## SERVICE LETTER 215

### DeHavilland DHC-2 Beaver 6100A & DHC-3 Single Otter 8000A Hydraulic Pump Replacement

Aircraft Makes/Model(s):	Float Model(s):	Compliance: Optional	By: MAB
DeHavilland DHC-2	6100A	Part Number: 1011601	Approved: SDW
DeHavilland DHC-3	8000A	Date: 5/26/2021	Revision: B

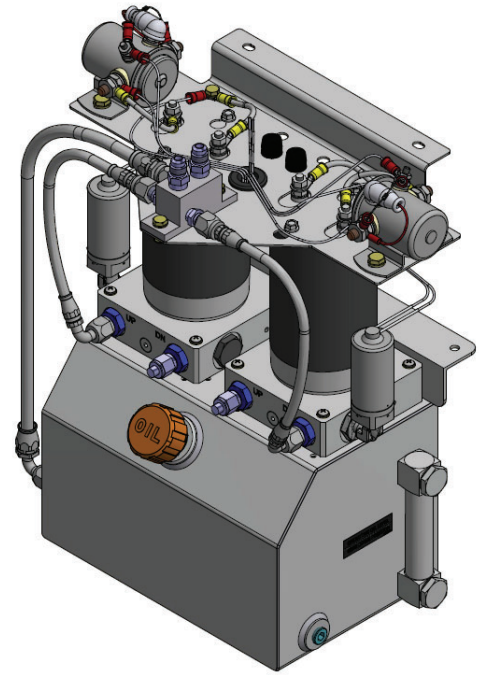
**DISCONTINUED**  
**HYDRAULIC PUMP 6A09000-029**

**NEW**  
**HYDRAULIC PUMP 1011404**

Hydraulic Pump Assembly p/n 6A09000-029 has been discontinued. This service letter provides the option to replace it with a new pump p/n 1011404.

**SOLENOID SCHEMATIC**

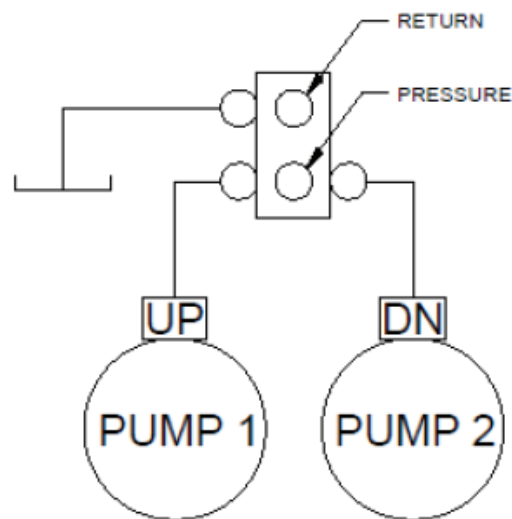
1. Pull Pump 1 and Pump 2 circuit breakers.
2. Remove and cap both pressure and return hydraulic lines on hydraulic pump manifold 6A09000-027.
3. Remove GA1 and GA4 wires (12 ga) from electrical solenoids terminal "D" on hydraulic power pack 6A09000-029.

**HYDRAULIC SCHEMATIC**

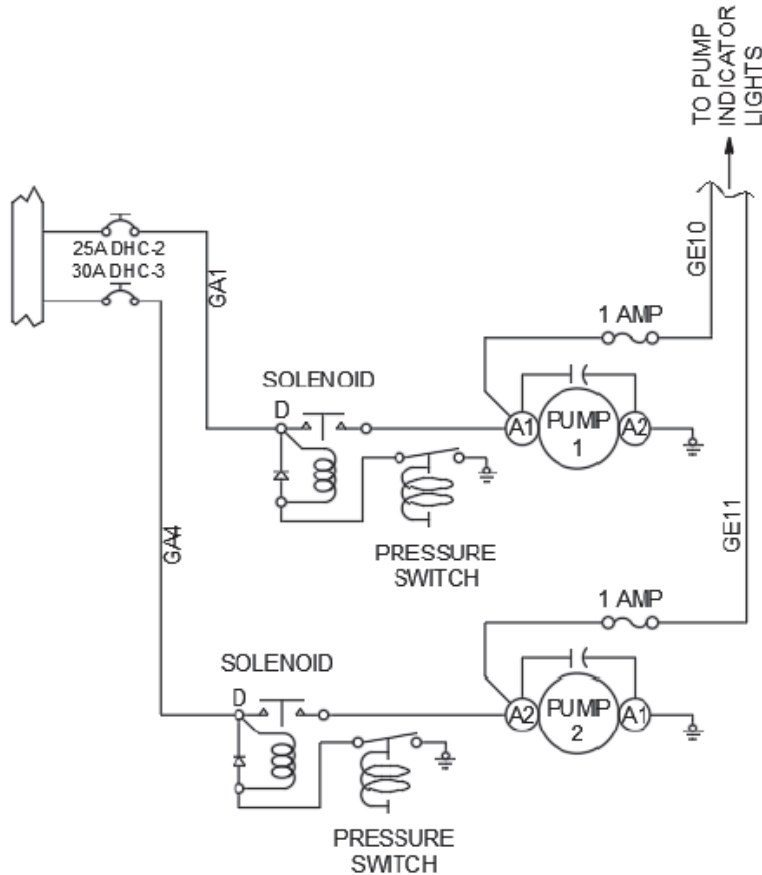
4. Cut GE10 and GE11 wires (20 ga) at butt splice connection.
5. Unbolt and remove hydraulic power pack 6A09000-029 from pump mount assembly.
6. Install new hydraulic power pack 1011404 onto pump mount assembly using existing hardware.
7. Install pressure and return line to hydraulic pump manifold. Refer to hydraulic schematic.
